### SERVICEORDRE – 2019-01

<b>HENVISNING:</b>	Firebird USA LLC (Product Service Bulletin FB 2019-01)
<b>FORMÅL:</b>	Visuell inspeksjon av kobling mellom reservepin og reservewire.
<b>STATUS:</b>	<b>Obligatorisk før neste hopp.</b>
<b>IDENTIFIKASJON:</b>	Reservepin på Firebird EVO seletøy SN# BD001 - CB010
<b>BAKGRUNN:</b>	30 mars 2019 ble produsenten gjort oppmerksom på at en reservepin hadde sluppet reservewiren i sammenkoblingen.
<b>SERVICE:</b>	Visuell inspeksjon av reservepin, der man skal idenifisere “senkings-merker” etter klemmeprosessen mellom reservepin og reservewire. Dersom tydelig senking ikke blir idenifisert, må riggen ikke hoppes før Firebird er varslet og komponenten undersøkt av Firebird USA LLC.
<b>UTFØRELSE:</b>	Utføres av MK.  Når inspeksjonen er utført merkes kontrollkortet med med SO 2019-01 gjennomført.
<b>DISTRIBUSJON:</b>	Klubber Hovedinstruktører Materiellkontrollører SU Sky Design Verksted Spot On Skyvoss F/NLFs internet sider Forsvaret Luftfartstilsynet

## Product Service Bulletin

**ISSUE DATE:** March 30<sup>th</sup> 2019  
**Bulletin Number:** FB 2019-01  
**SUBJECT:** Reserve pin ripcord assemblies on Firebird EVO Harness Containers  
**STATUS:** *

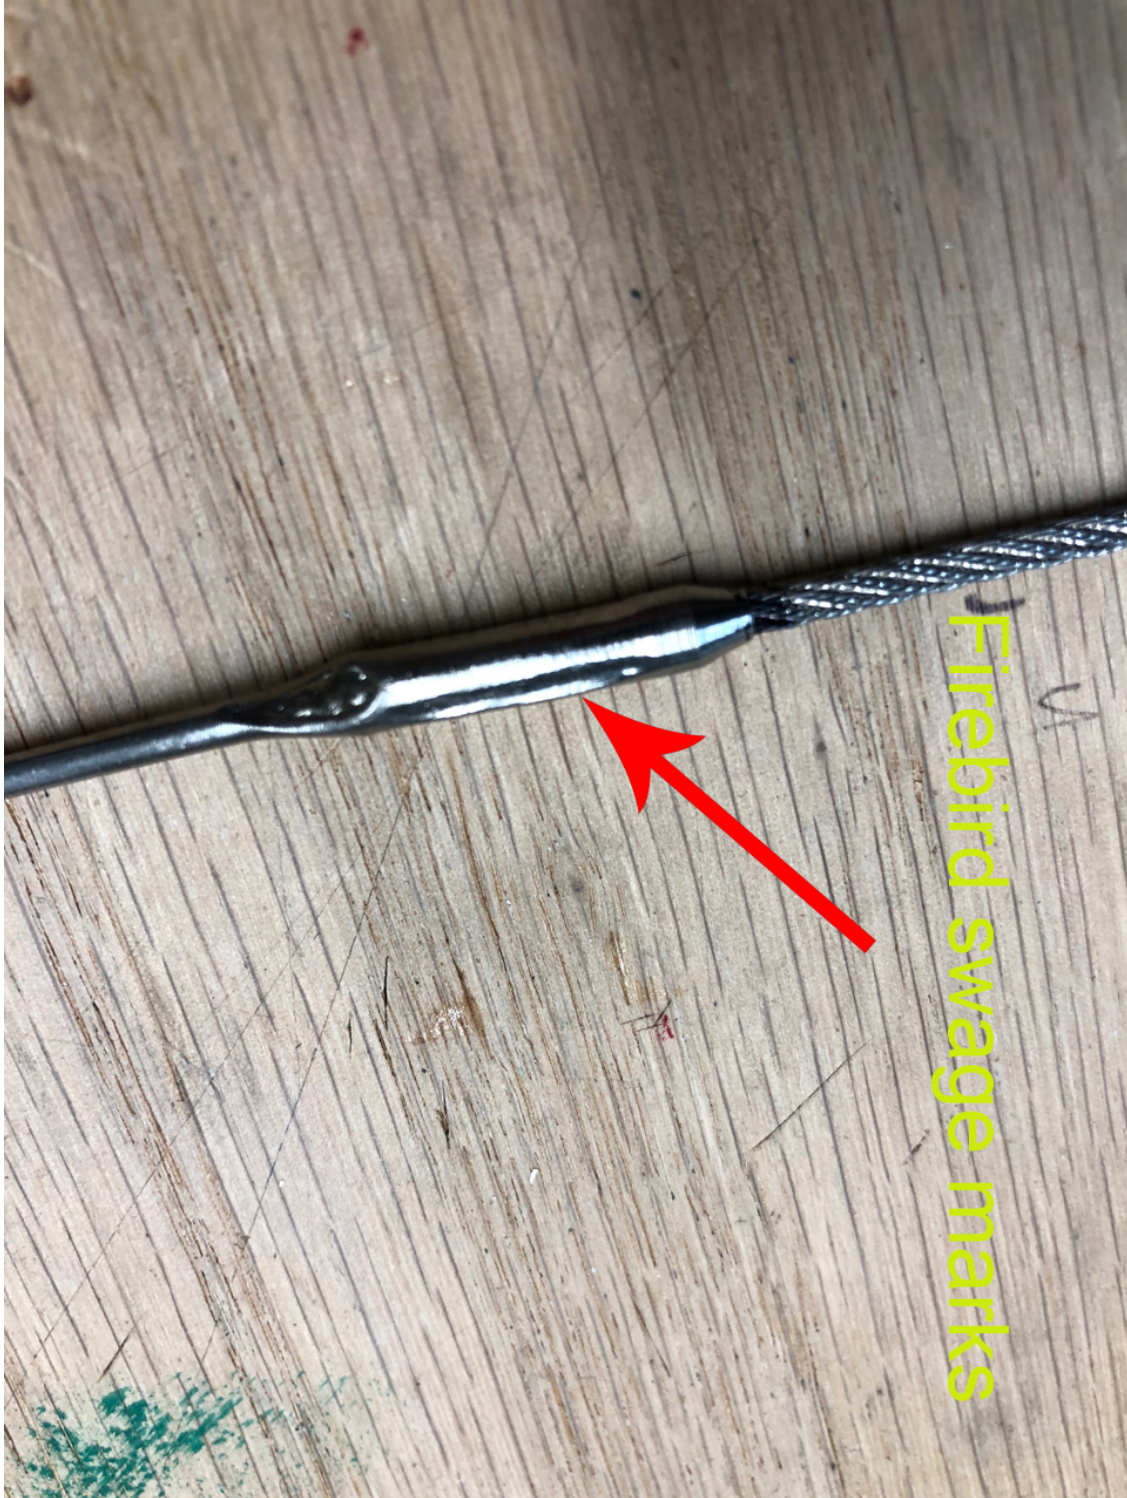
If your HC has a ripcord pillow ripcord assembly installed between SN BD001 and CB010 they have to be visually inspected for swaging marks.

If your reserve pin doesn't have clear swage marks as pictured, DO NOT JUMP until notification and further inspection through Firebird USA LLC.

**MANDATORY** visually inspection of the pin cable junction by a FAA certified Senior or Master Rigger (or national equivalent) before next jump.
